Re: WWTP Improvements Project: Change Order #9

CHANGE ORDER NO.: 9

FIELD DIRECTIVE

SUBJECT: City of Greenfield WWTP Improvements
Field Directive—Dump Boundary

Attachment(s): Sheet PS9 Dump Confines Markup

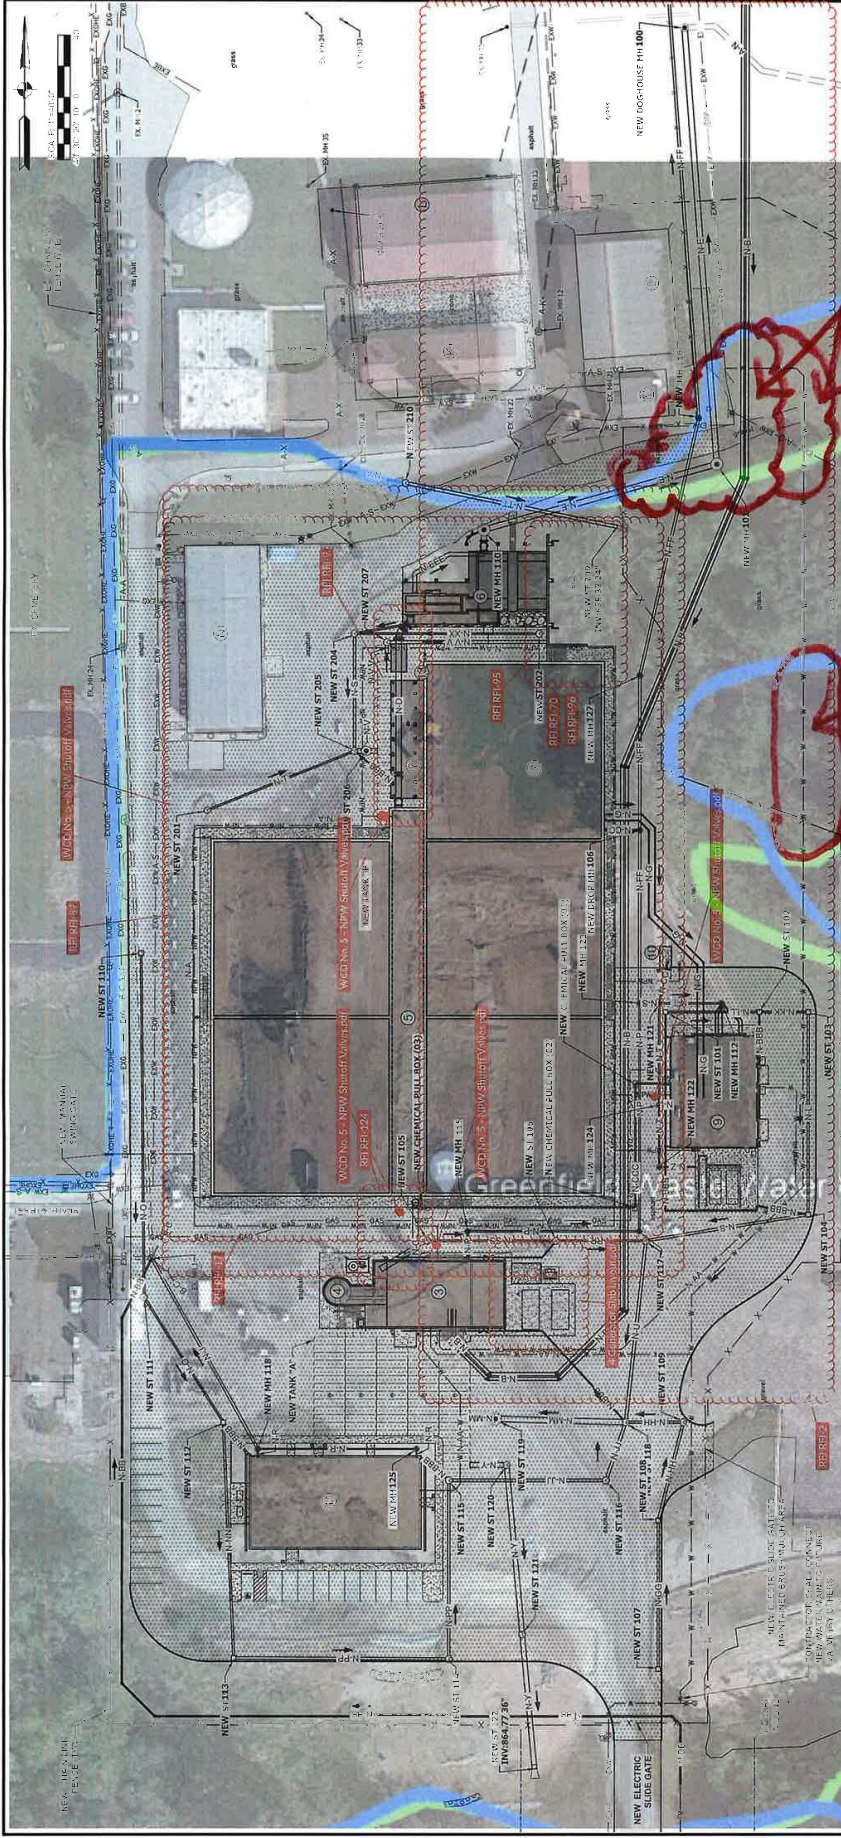
The attached figure demonstrates an update on the dump confines. The figure shows the originally proposed waste boundary extent in green. The updated waste boundary is shown in blue. The figure is marked up denoted one area no longer within dump confines, and one area added to the dump confines. Please proceed with trenching procedures accordingly.
